Service-Bulletin

Washing machines

599 522 112 EN

Program abort fault display EA0 / fault memory EA6 with program start

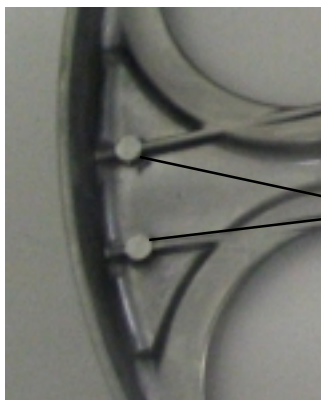
Disassemble belt pulley and DSP.

Assemble DSP at the top with one washer, at the bottom with two washers.

Onewasher

Two washers
